These amendments relate to the operation of the Surry Unit Nos. 1 and 2 with a positive moderator coefficient in the power range.

SURRY POWER STATION UNIT NO. 1

Amendment No. 19  
License No. DPR-32

SAFETY EVALUATION BY THE OFFICE OF NUCLEAR REACTOR REGULATION  
SUPPORTING AMENDMENTS NO. 19 TO LICENSES NOS. DPR-32 AND DPR-37  
VIRGINIA ELECTRIC AND POWER COMPANY  
SURRY POWER STATION UNITS 1 AND 2  
DOCKETS NOS. 50-280 and 50-281

Figure 1

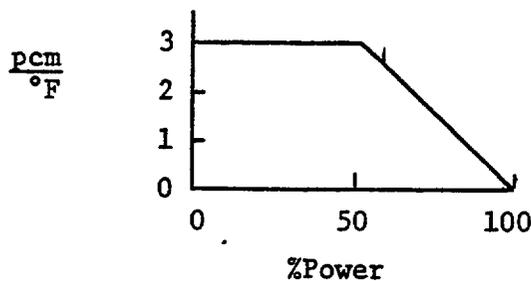
The Virginia Electric and Power Company has reexamined the accidents and transients presented in the Final Safety Analysis Report (FSAR) for sensitivity to a positive moderator coefficient. With the exception of the rod withdrawal from subcritical and rod ejection accidents all transients reanalyzed used a constant moderator coefficient of  $+3 \text{ pcm}/^{\circ}\text{F}$  ( $+0.3 \times 10^{-4} \Delta\text{K}/^{\circ}\text{F}$ ). This is conservative since, as shown in Figure 1, the coefficient is constant to 50% power and then decreases linearly to zero at 100% power.

1. Except during low power physics tests, the reactor shall not be made critical at any temperature above which the moderator temperature coefficient is more positive than:
  - a) +3 pcm/°F at less than 50% of rated power, or
  - b) +3 pcm/°F at 50% of rated power and linearly decreasing to 0 pcm/°F at rated power.
2. In no case shall the reactor be made critical with the reactor coolant temperature below DTT +10°F, where the value of DTT + 10°F is as determined in Part B of this specification.
3. When the reactor coolant temperature is below the minimum temperature as specified in E-1 above, the reactor shall be subcritical by an amount equal to or greater than the potential reactivity insertion due to primary coolant depressurization.
